# SUBMITTAL CHECKLIST

FOR ENCROACHMENTS & ENCUMBRANCES IN THE PUBLIC RIGHT-OF-WAY

Project Name: 2811 Walnut  
Adjacent Property Address: 2811 Walnut Street Denver, CO 80205  
Coordinates (Lat/Long): 39.761560, -104.983840  
Encroachment Area, in SF: 295 SF

# Comment Report

1 ENLARGED PLATFORM AND STAIR PLAN 1  
A-411 1/2" = 1'-0"

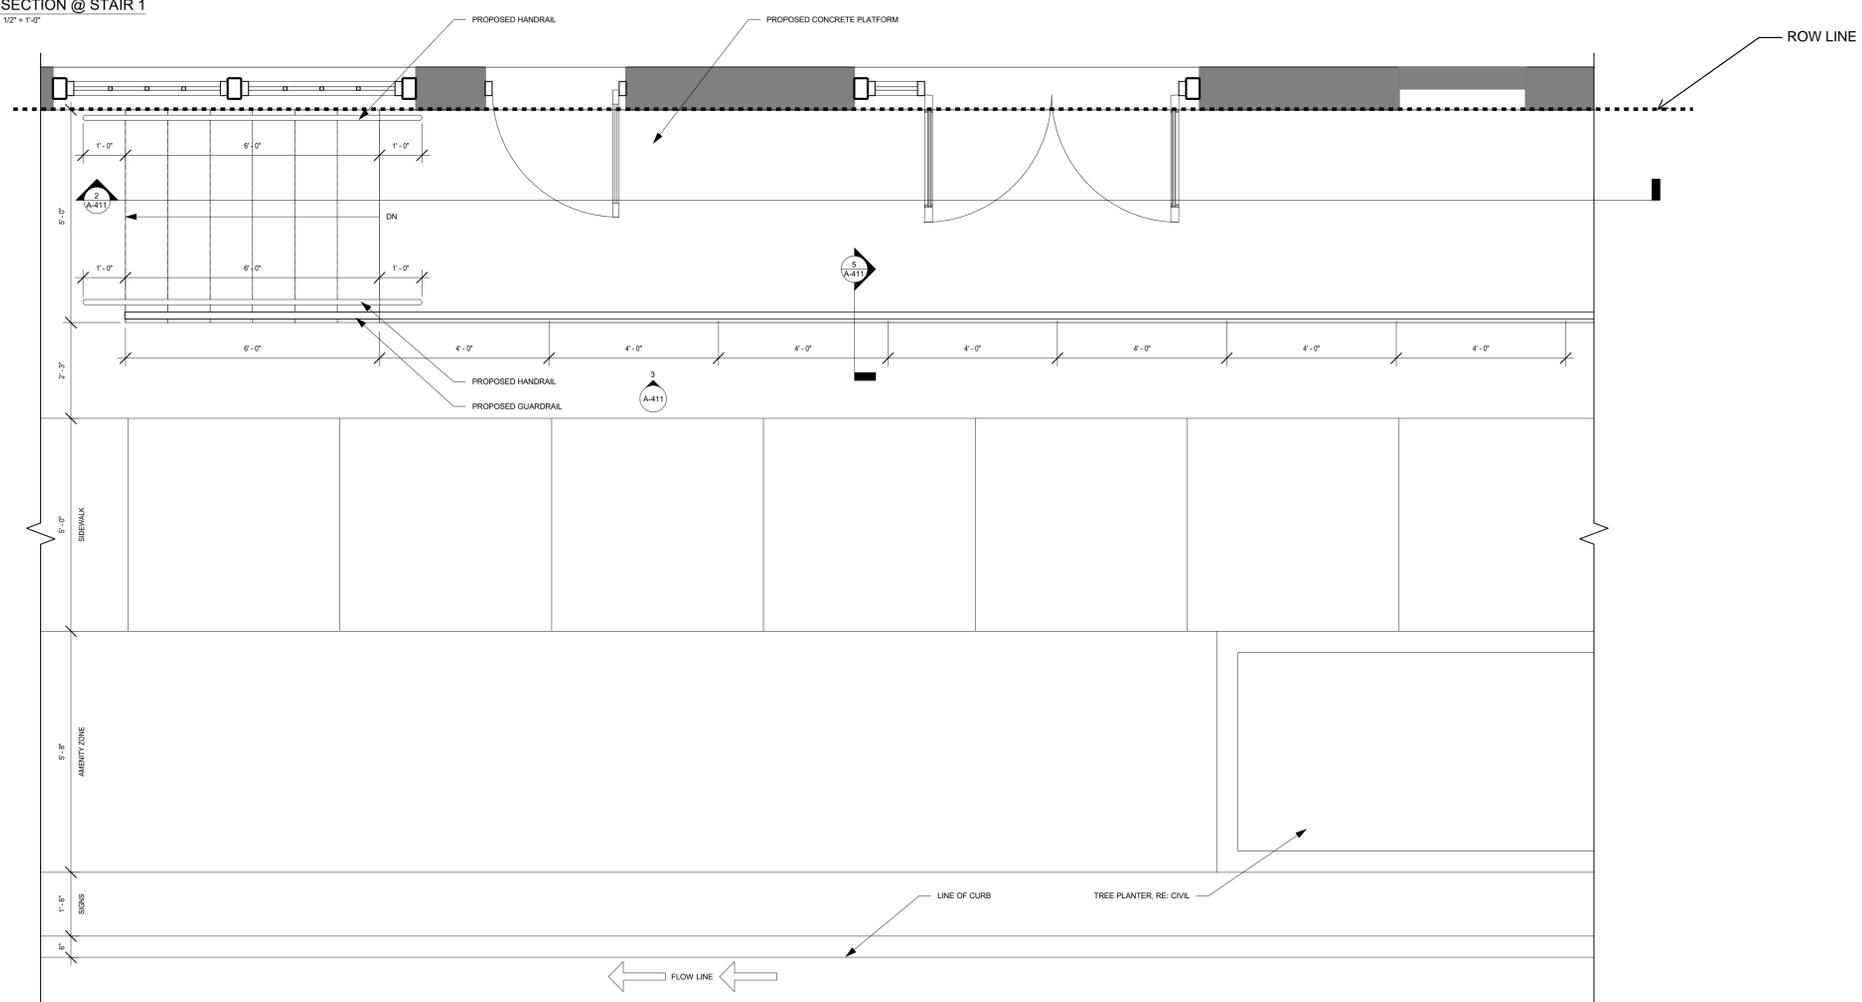
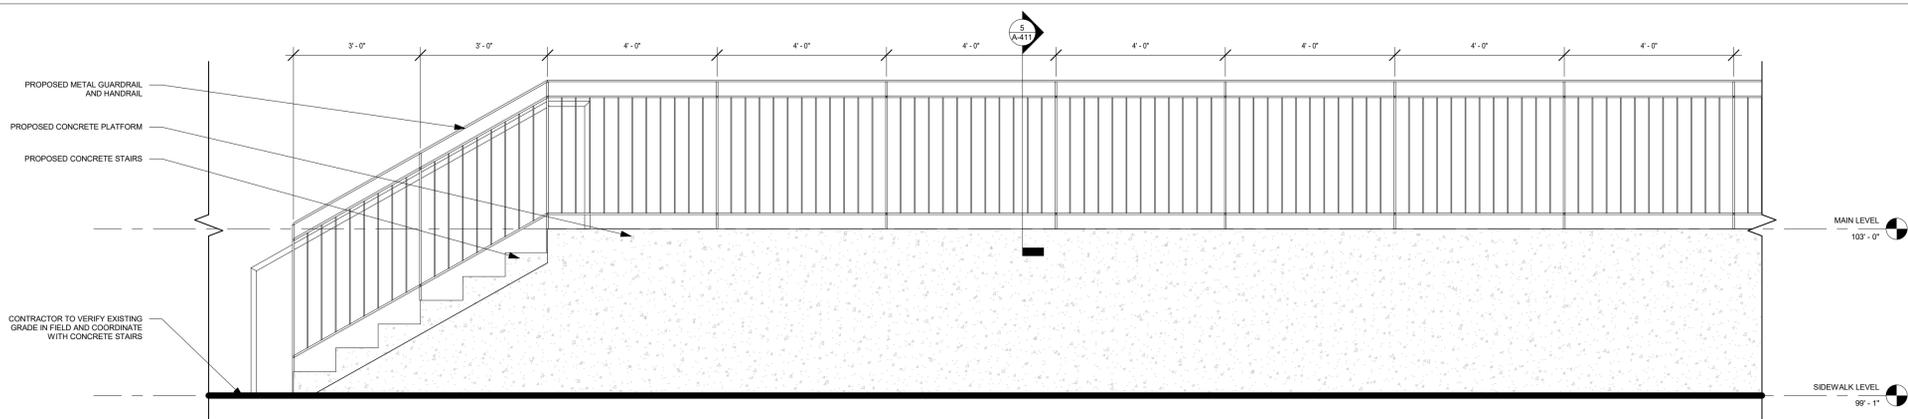
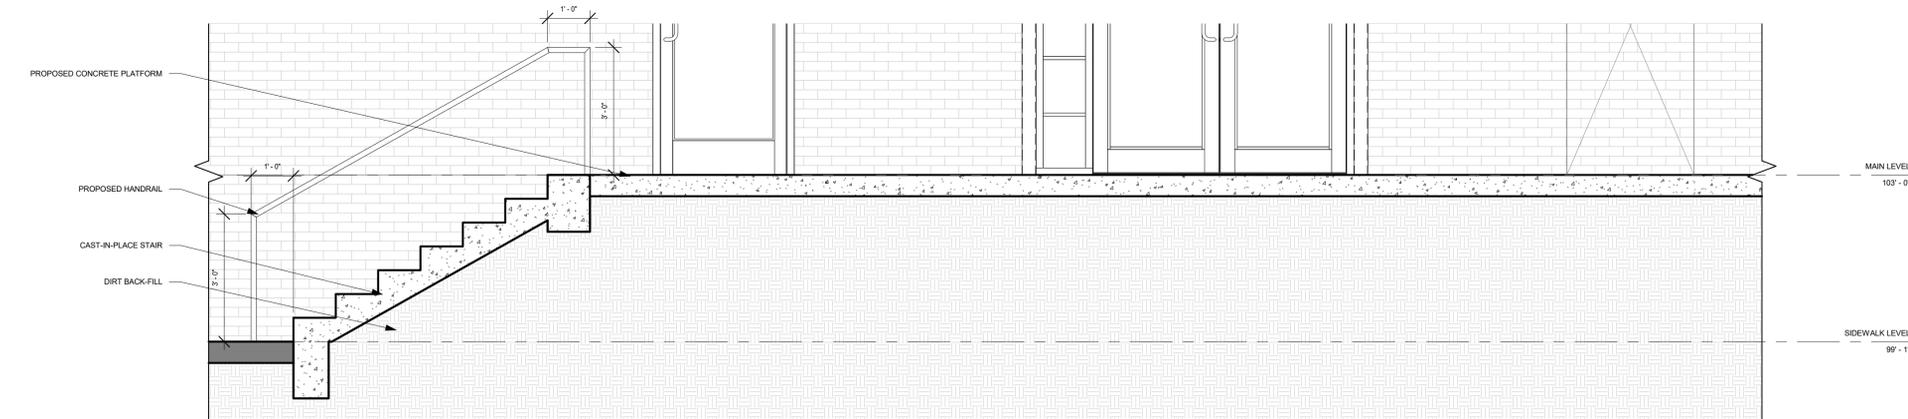
Comments:  
Provide structural plans, details and calculations for retaining wall. Structural plans must be stamped and signed by a licensed engineer. 2. Retaining wall, stairs and walkway may not encroach more than 5 ft into the ROW. Identify ROW on dimensioned site plan.

Comments: 1. Provide structural plans, details and calculations for retaining wall. Structural plans must be stamped and signed by a licensed engineer.

2. Retaining wall, stairs and walkway may not encroach more than 5 ft into the ROW. Identify ROW on dimensioned site plan.

Comments:  
The attached plan, received 11/30/22 has been revised to address our comments

# ILLUSTRATION FOR EXHIBIT B

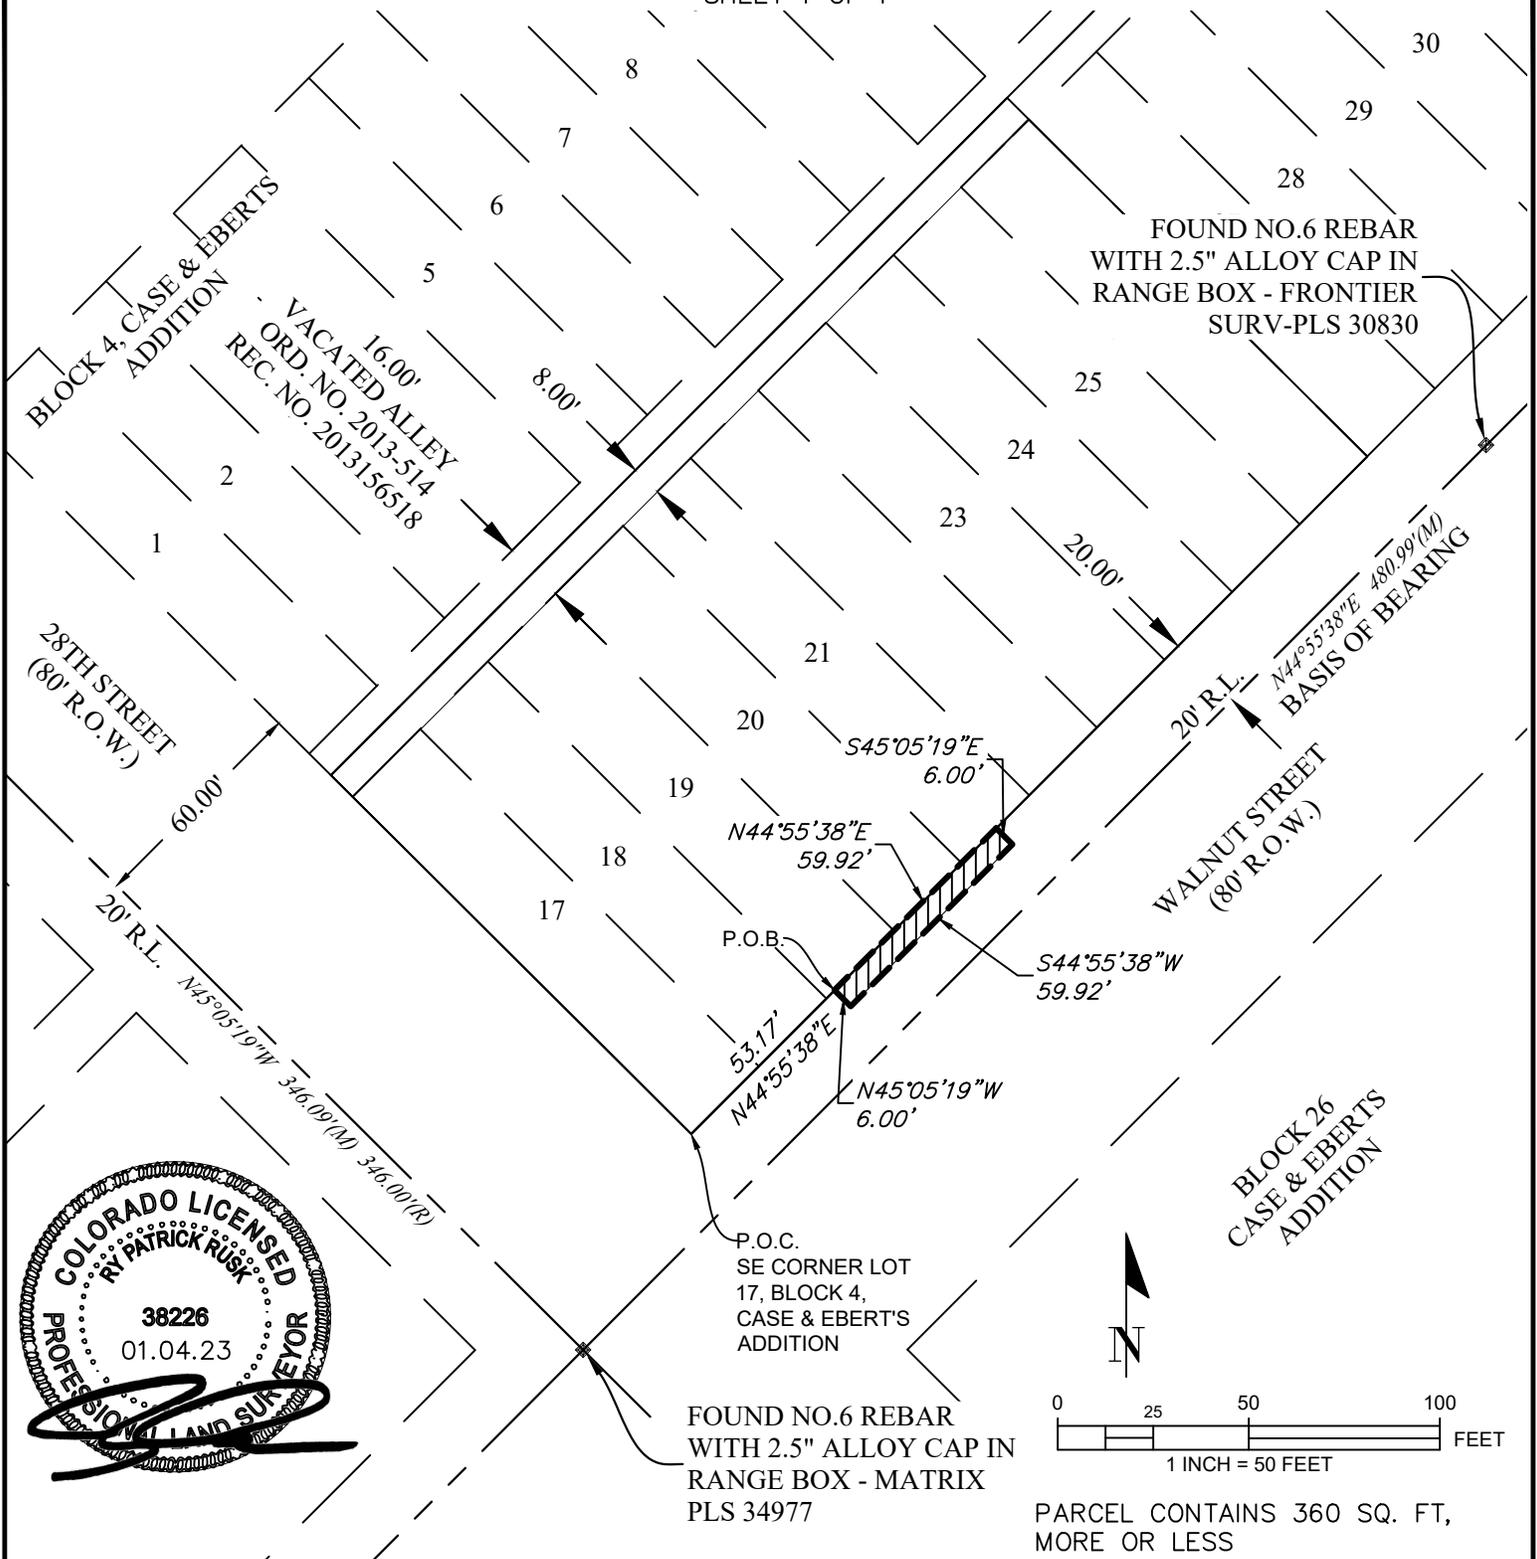
Show any required legal description on site plan, including ties to property corners, etc to ensure stairs are within the described area.
